DATE: February 23, 2021

MEMORANDUM

TO: Elizabeth Hughes, Town Planner
COPY: Alan Cathcart, Acting Director of Public Works
VIA: Steve Dookran PE, Town Engineer
FROM: Justin Richardson PE, Assistant Town Engineer
SUBJECT: 246 Old Road to Nine Acre Corner: Concord Country Club Earth Removal Special Permit

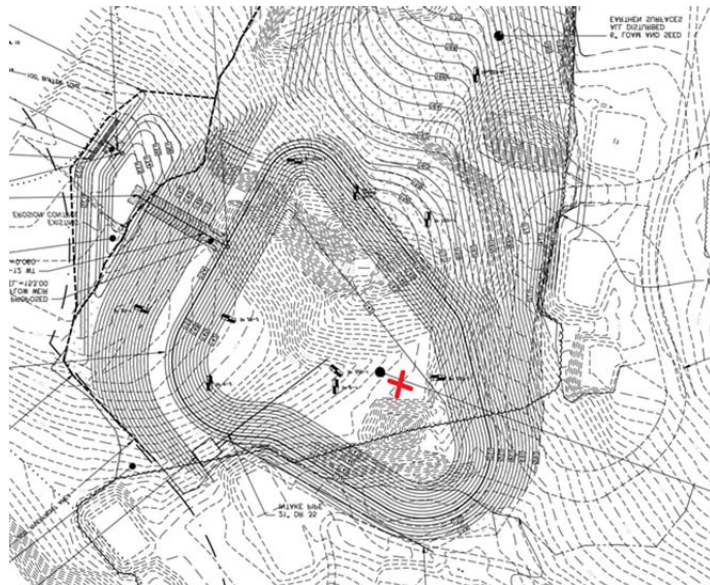
- 1. TP 6-1 is not located in the correct location. The correct location shown below, is located immediately adjacent to the earth pile that is shown on the existing topographic plan below.**

Further confirmation of the hole locations are from pictures from the June 2, 2020 site visit and A level run that was performed by Onyx Corporation prior to the hole being dug which specified an elevation of 155.10'. This has considerable effects to the design setting the seasonal high ground water elevation at 139.10'. Pursuant to Zoning Bylaw Section 7.6.6.11,

- *The location of TP 6-1 and its elevation have been corrected. The pond bottom has been revised to hold a minimum of 4' to the estimated seasonal high groundwater table.(11/17/2020)*

- **The location of TP 6-1 needs to be moved in the east to be immediately adjacent to the pile located on the existing conditions plan and above the 155.00' contour. Please revise to the plans to show the test hole in the appropriate location. Engineering concurs that the bottom of the basin in this area is more than 4' above seasonal high groundwater. (discussed in the 12/9/2020 meeting)**

- *The location of TP 6-1 has been corrected.(12/15/2020)*
 - **Comment has been addressed (12/31/2020)**
- 2. **TP 7-2 according to the point description and existing conditions survey is at elevation 154.435'. The soil log is consistent with Engineering's notes from the site visit on July 2, 2020 that season high ground water is located 86-inches measured from the ground surface as the hole location (154.435'). This means that the seasonal high ground water elevation in that area is 147.27', which means that the bottom of the basin is within the four foot to seasonal high groundwater. Pursuant to Zoning Bylaw Section 7.6.6.11, removal of soil, loam, sand, gravel, or any other mineral substance within four feet of the historical high groundwater table elevation is prohibited within the Groundwater Conservancy District.**
